# REPAIRS TO SEAWALL AT 6B CHILDE STREET

## RESPONSES TO RFI BY NSW COASTAL PANEL

**RE: NO 6B CHILDE ST, BELONGIL**

**REF DOC 17/8231**

Figure 1

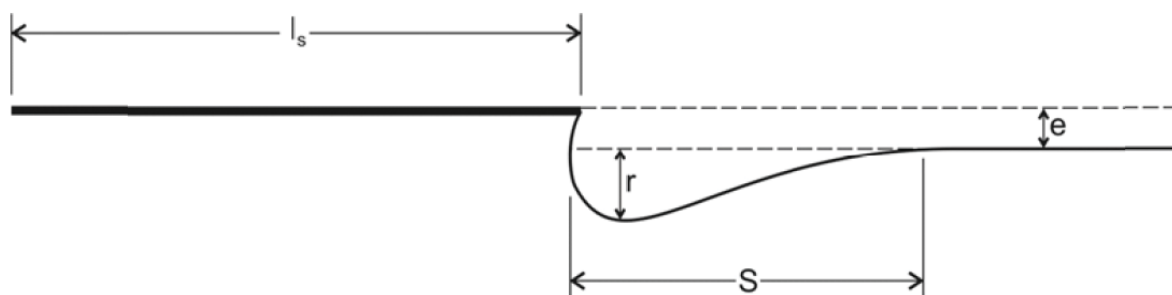
**Q8. An assessment of end effects to both the north and south of the structure, or if contiguous with another structure, the impact on that structure, including but not limited to any ‘tie-in’ arrangements. This assessment should include a diagram illustrating the potential end effects of the structure.**

a. Such diagram to be prepared in accordance with the methodology in *McDougal et al 1987* or other reputable methods or modifications and is to include a specification of the (S), (r), (e) and ( $l_s$ ) values used and how they were determined. If the shape of the end effects calculated does not conform to the shape in *McDougal et al 1987* or other reputable methods, an explanation of the variation is to be provided.

**Response:** An assessment of such effects was provided in the original application. McDougal et al 1987 provided the following diagram for end effects of seawalls on a straight beach:

The proposed works are part of a near continuous seawall on a **curved** beach that stretches from the northernmost private property on Belongil Spit to Border Street. Southward of border Street and along the old Jetty site, natural coffee rock forms a limiting structure as does the Jonson Street structure (WRL 2013). WRL (2013) calculated that the total length ( $l_s$ ) is 1,727m. The subject wall is about 40m long (about 3%) including the 10m tie ins at each end..

Similarly, as the proposed repairs are to an existing section of the seawalls and is only about 3% of the length of hard structures on the beach, the proposed repair works will have *“no additional (incremental) impact beyond the status quo”* on the magnitude of variables r

and S in the formula even if it were applicable and the proposed repair works will “*reduce the likelihood of flanking failure to surrounding protection works*”.

PROJECT NAME <b>BELONGIL SEAWALL REPAIRS</b>	
DRAWING TITLE <b>X-SECTION (PRESENT) 6 CHILDE STREET</b>	
DRAWING No. <b>BSR - CS5 - 003</b>	REVISION: <b>A</b>
DRAWN: SK	CHECKED: AJ
APPROVED: AJ	RPEQ 2876
SIZE: A3	SCALE: A3
DATE: 28 Feb, 2017

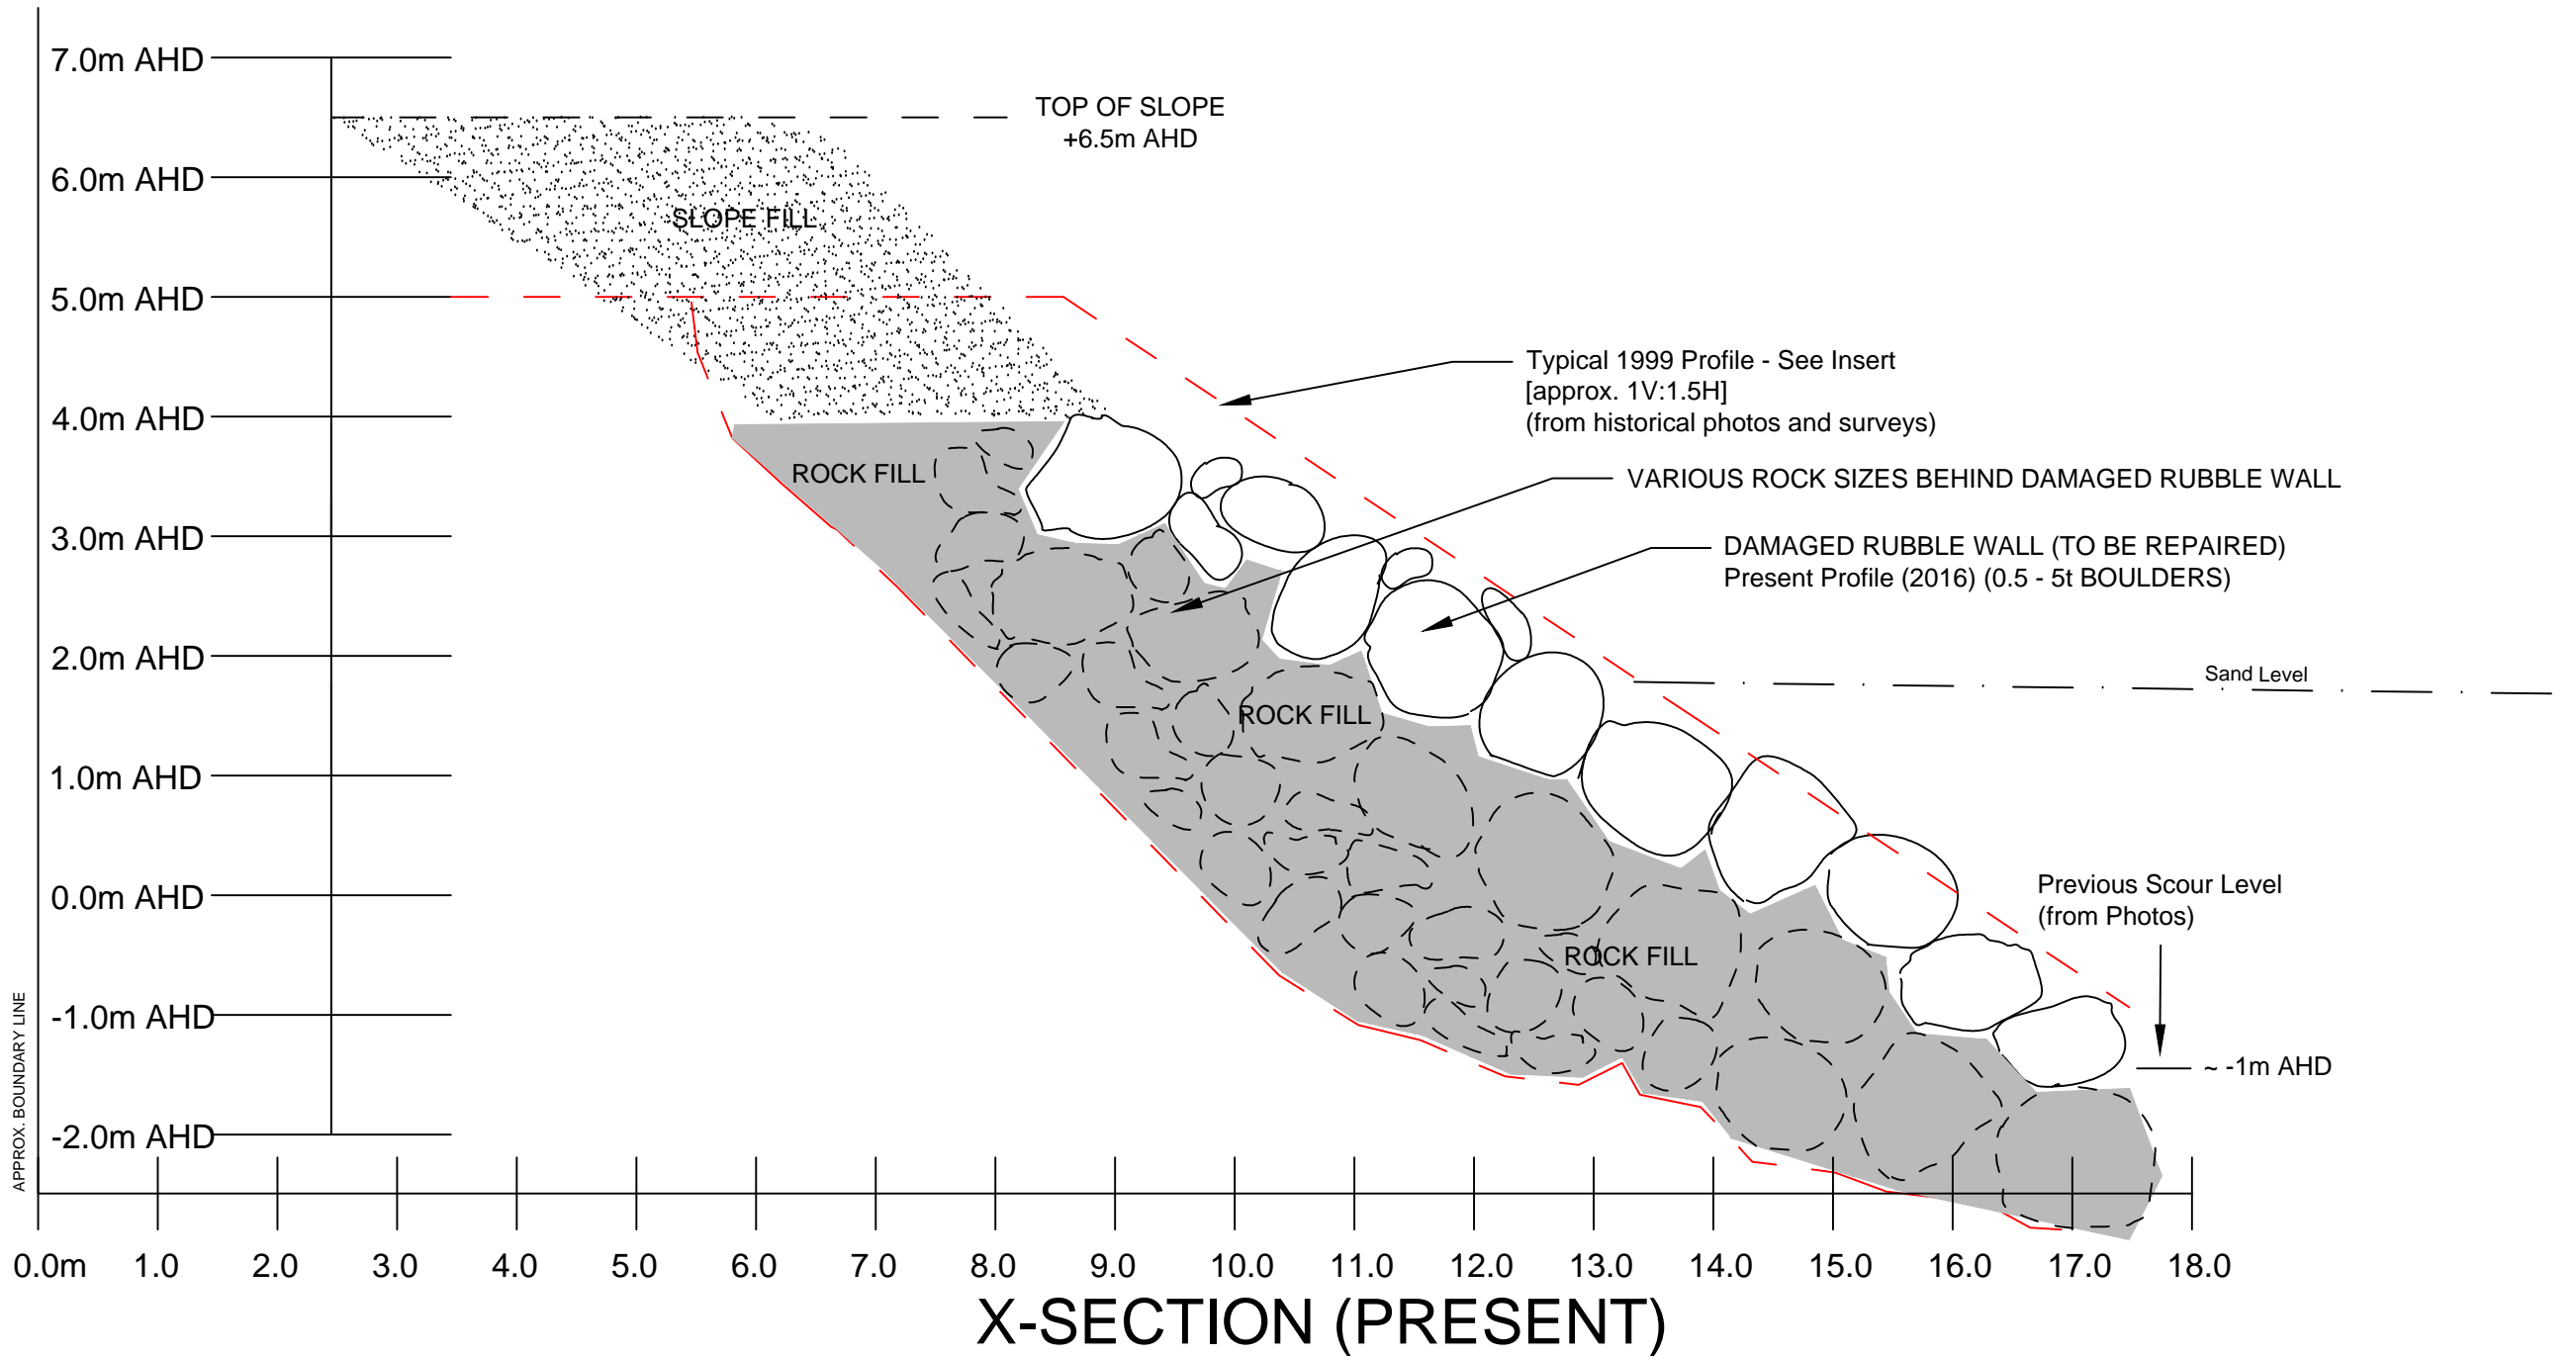
- a. A detailed survey plan depicting the cadastre, proposed footprint of the structure, existing property boundaries (including the crown road reserve) and specifying all relevant dimensions of the proposed structure.
- b. Sufficiently accurate cross sections of the proposed structure (including its proposed points of termination and/or method or tie if there are existing approved works on either side) and its location relative to the existing property boundaries (including the crown road reserve). Such cross sections to clearly specify all relevant dimensions (including crest, toe and existing beach levels)

**Response: Response:** Additional survey and cross section details requested in a and b have been added to the existing drawings on the technical drawing set that was previously provided. The revised drawings are attached as Attachment A.

**Response:** As per x-sections in drawings – Attachment A.

**Response:** As per x-sections in drawings – Attachment A.

DRAWING No. **BSR - CS5 - 004** REVISION: **A**

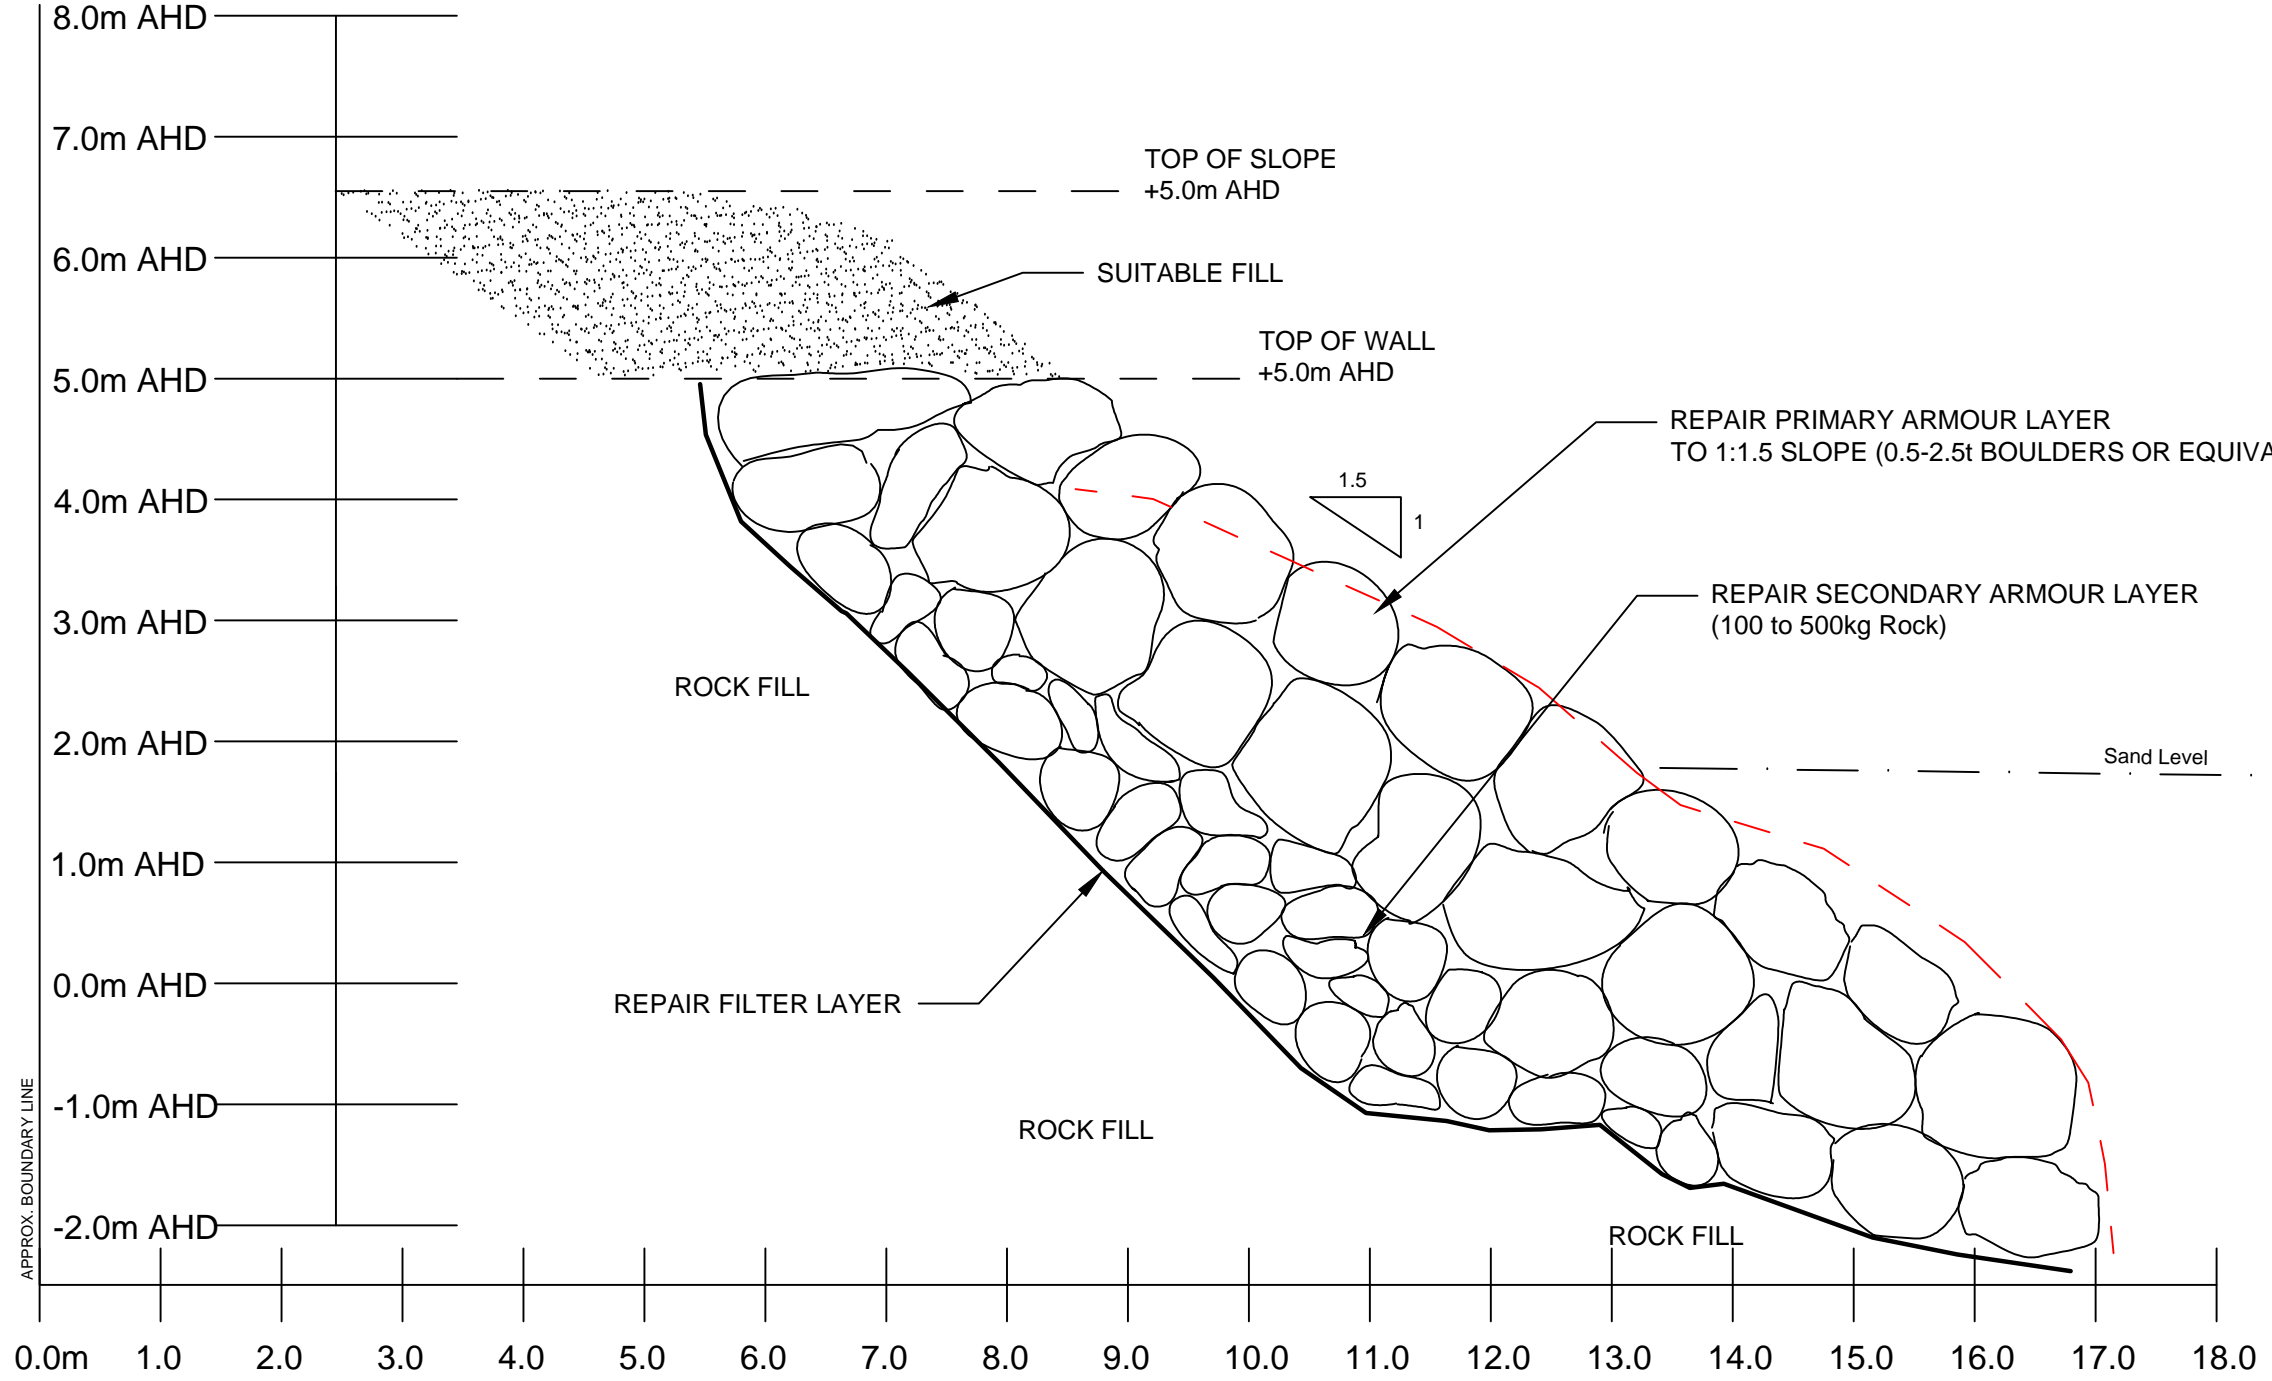
**The engineering report should also detail how the proposed structure will tie in to existing structures to the north and south of the proposed development, and how the expected differences in engineering standards will be managed with respect to the considerations outlined in s55M of the *Coastal Protection Act 1979*.**

**Response:** The structure will tie in to adjacent structures by 10m as shown on the drawings (Attachment A). This transition will minimize differences between adjacent structures.
